City of San Antonio
TRANSPORTATION AND CAPITAL IMPROVEMENTS

ADDENDUM NO. 4

PROJECT NAME: **Ray Ellison (Loop 410 to Old Pearsall Road)**

PROJECT NO.: **40-00312**

UTILITY NOTE:
THE LOCATIONS OF THE EXISTING UTILITIES HSOWN ARE TAKEN FROM THE BEST INFORMATION AVAILABLE. THEY ARE NOT GURANTEED TO BE ACCURATE AND MUST BE VERIFIED BY THE CONTRACTOR PRIOR TO THE START OF CONSTRUCTION.

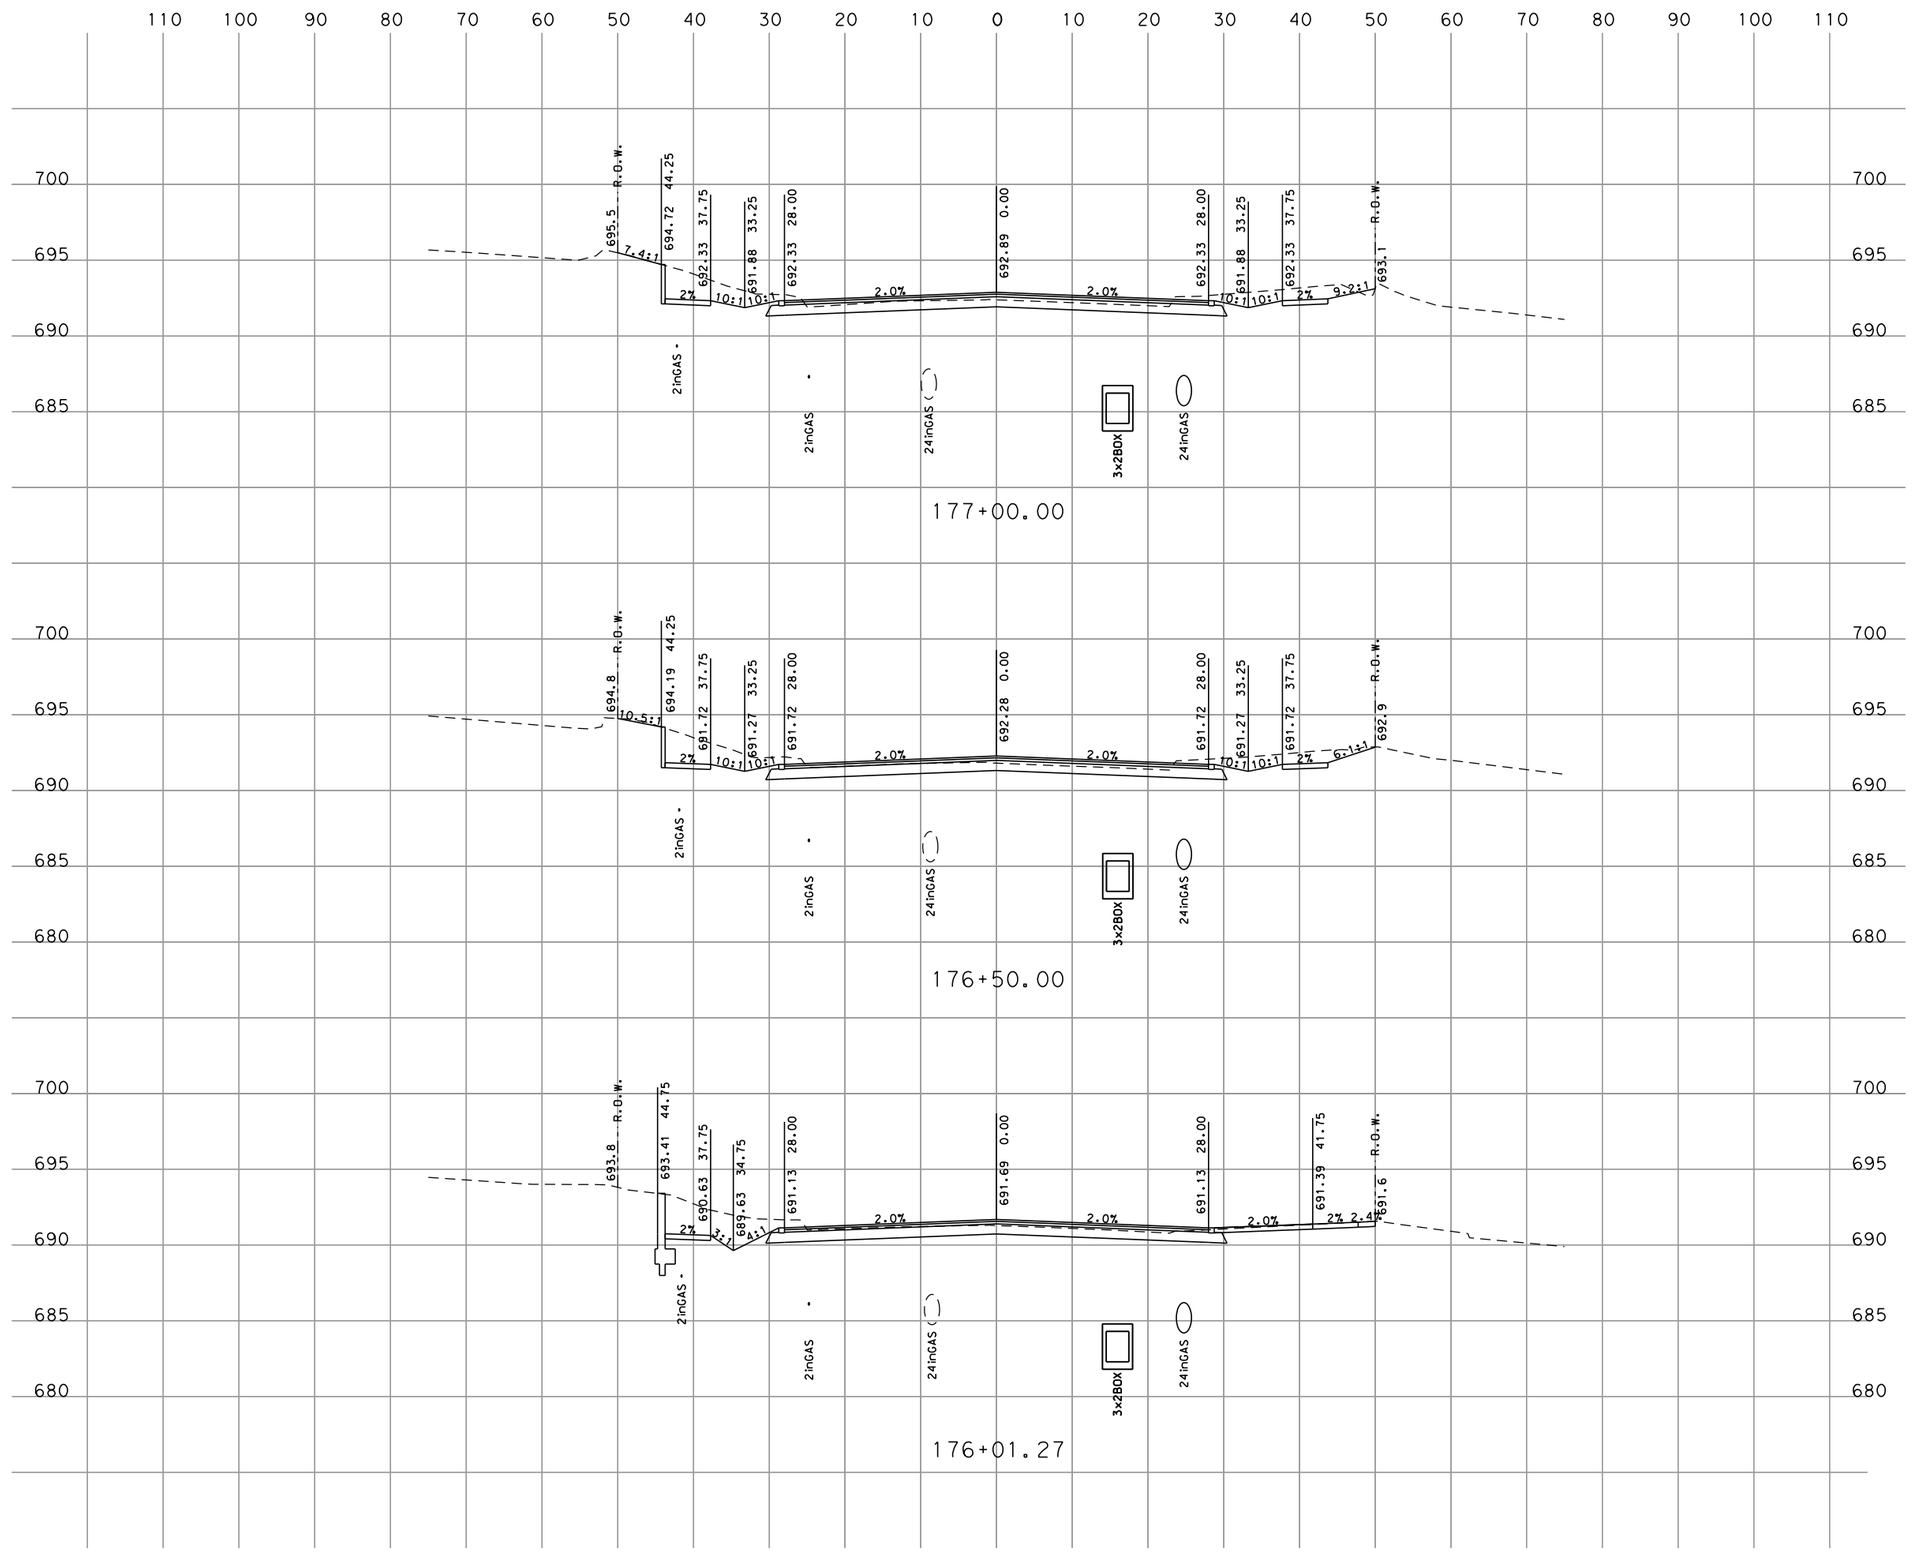
- Replace Sheet L2.2 “Planting Details and Plant Lists” with Addendum No. 4 Sheet L2.2 “Planting Details and Plant Lists.” Revised plants.
- Replace Sheet 394 “Proposed Cross Sections” with Addendum No. 4 Sheet 394 “Proposed Cross Sections” Revised retaining wall and sidewalk.

- Replace Sheet 395 “Proposed Cross Sections” with Addendum No. 4 Sheet 395 “Proposed Cross Sections” Revised retaining wall and sidewalk.
- Replace Sheet 396 “Proposed Cross Sections” with Addendum No. 4 Sheet 396 “Proposed Cross Sections” Revised retaining wall and sidewalk.

- Replace Sheet 397 “Proposed Cross Sections” with Addendum No. 4 Sheet 397 “Proposed Cross Sections” Revised retaining wall and sidewalk.
